**WASTEWATER STUDY
FOR
SOUTH SCOTTSDALE**

**PRELIMINARY Basis of Design
Report**

PRELIMINARY SEWER MAP
 SOUTH SCOTTSDALE
 2340 N. HAYDEN ROAD

**WATER REPORT
FOR
SOUTH SCOTTSDALE**

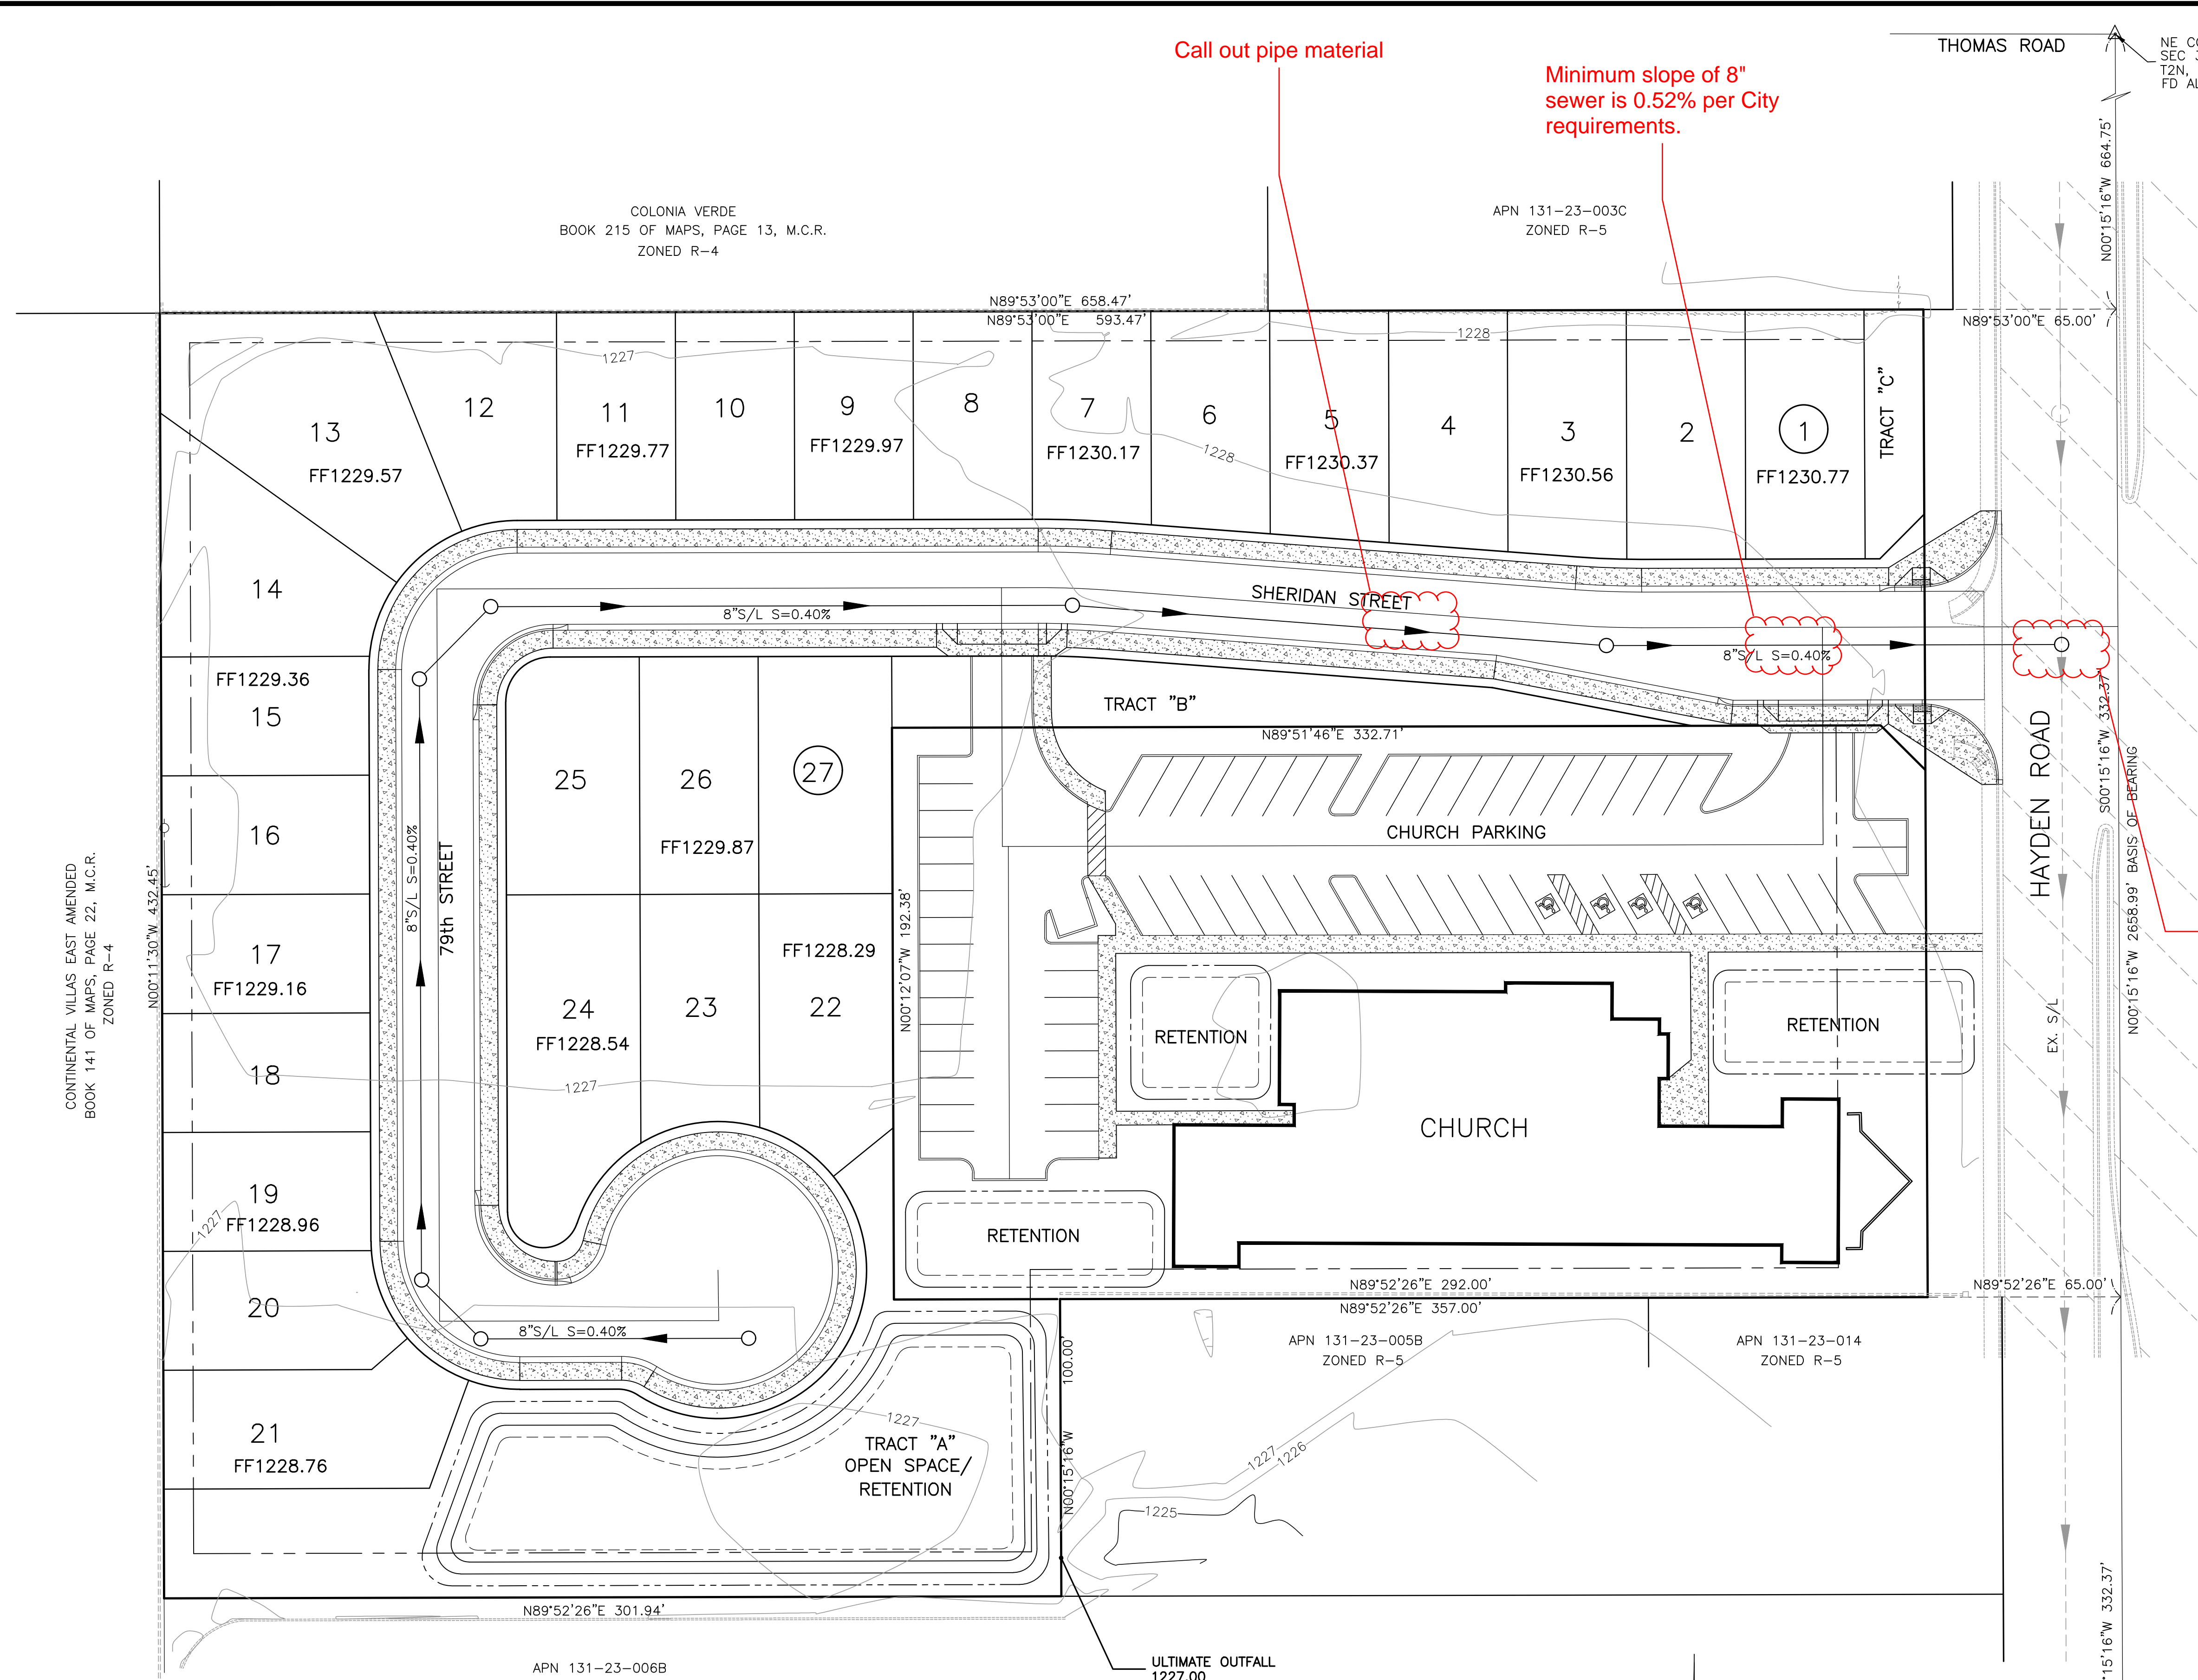
1.Note to the Submitter/Developer, as per section 7-1.400.A of the DSPM, Developers may be required to install, at their expense, all on-site and off-site improvements, if required. Offsite implications.: 5foot diameter manhole on Hayden Rd sewer with coating or other corrosion protection, and drop connection if justified per depth. STIPULATION

2.Call out new 5ft diameter manhole in Hayden Road. Will need to have drop connection if justified by depth. Will need to be coated for corrosion protection or constructed of inert materials (PVC or polymer concrete). DS&PM 7-1.405. STIPULATION

4.There is no description of the residential services per DSPM Section 7-1.201. Indicate in utility plan.

7.Please indicate the material type of the new 8-inch sewer line in the Wastewater BOD Report and the Sewer Map.

8.In the Wastewater BOD Report, please state the size and pipe material type for the house service laterals. Call out lateral connection 440-3 and show clean-outs in ROW.

PRELIMINARY WATER MAP
SOUTH SCOTTSDALE
2340 N. HAYDEN ROAD

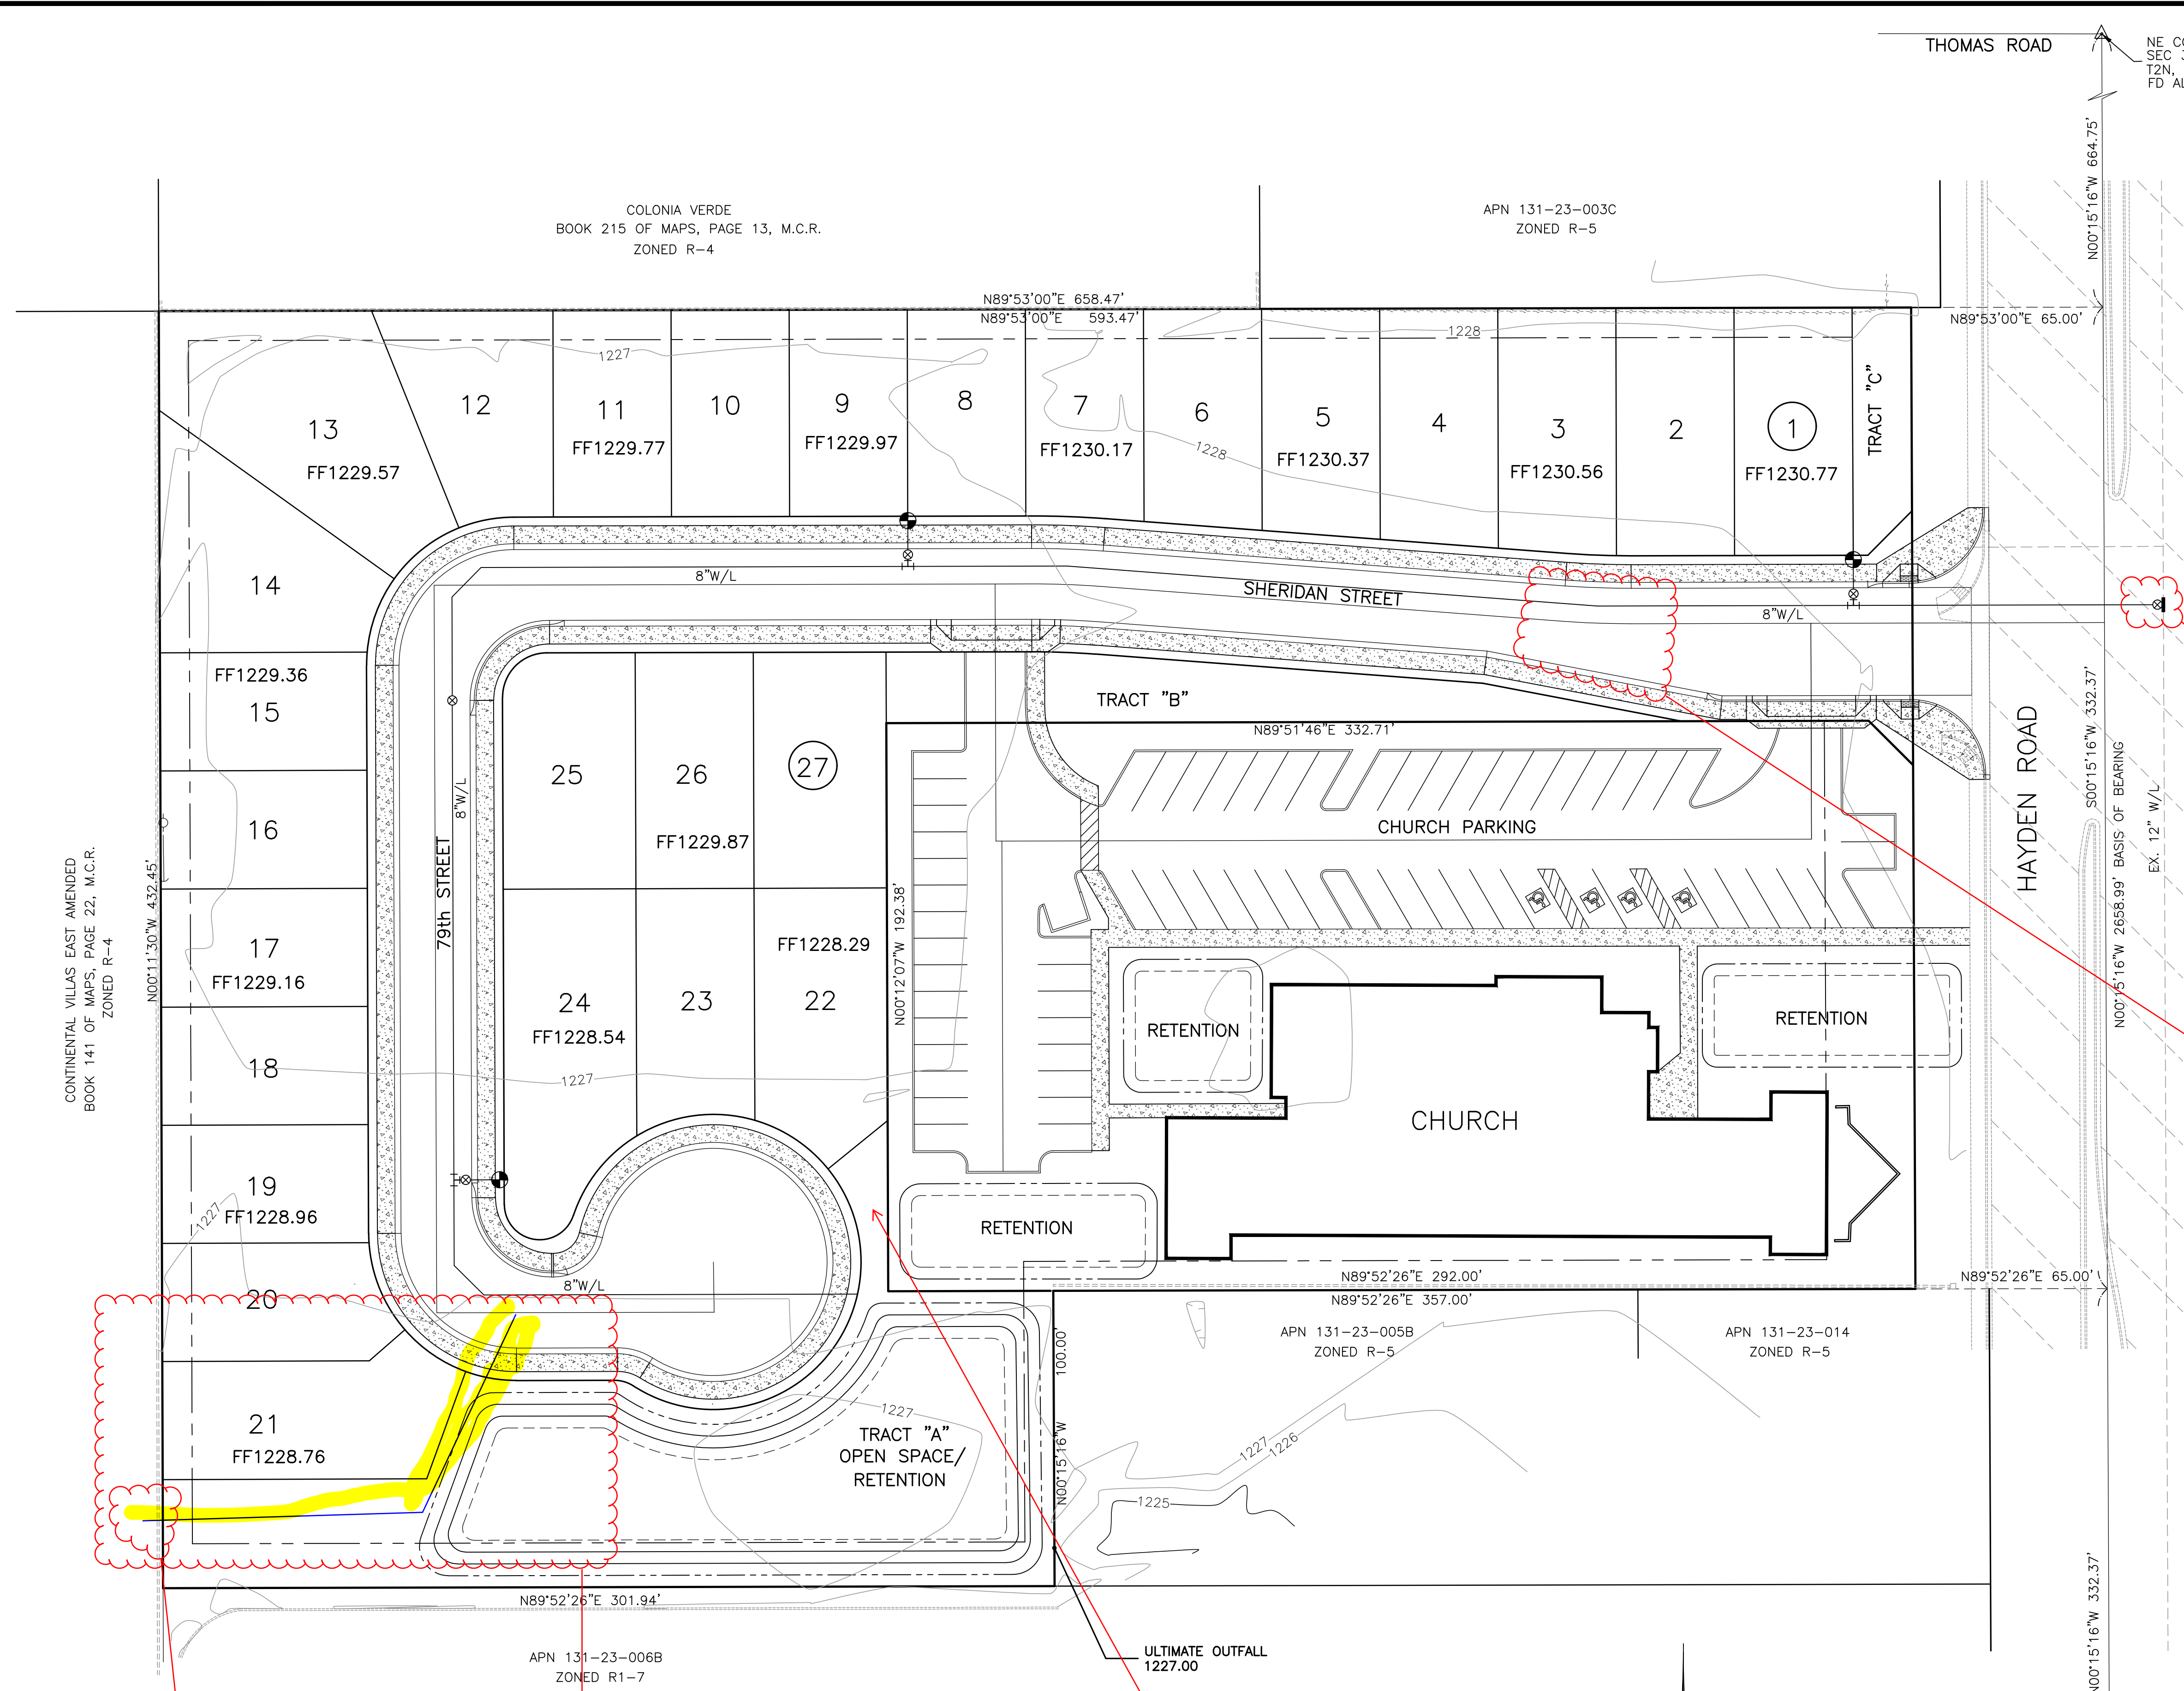
Indicate proposed sewer main and service line locations to evaluate conflicts with water pipelines and required separation (6ft clear)

This 12" main is a cast iron pipe (CIP) per City GIS. Removal of a minimum of 1 segment of CIP pipe and replacement with DIP pipe and a reducing tee and isolation valve(s) will be required. Coordination with the City to isolate this main would be required.

Removal of a minimum of 1 segment of existing 6" ACP pipe and replacement with DIP pipe and a reducing tee and isolation valve will be required. Coordination with the City to isolate this main would be required.

DS&PM 6-1.402 Loop the new 8" water line to connect to the existing alley 6" ACP line. Refer to preapp comments at front of document on details required

DS&PM 6-1.418 Water sampling stations are generally required in all new residential subdivisions consisting of twenty or more platted lots. Developers shall contact the Water Quality Division prior to the preliminary plat submittal for a determination. Sampling stations are to be located within the right-of-way, a private street tract, or utility easement at mid-street, 3 feet behind the sidewalk, along a property line extension. Construction will be per COS Standard Detail No. 2349.
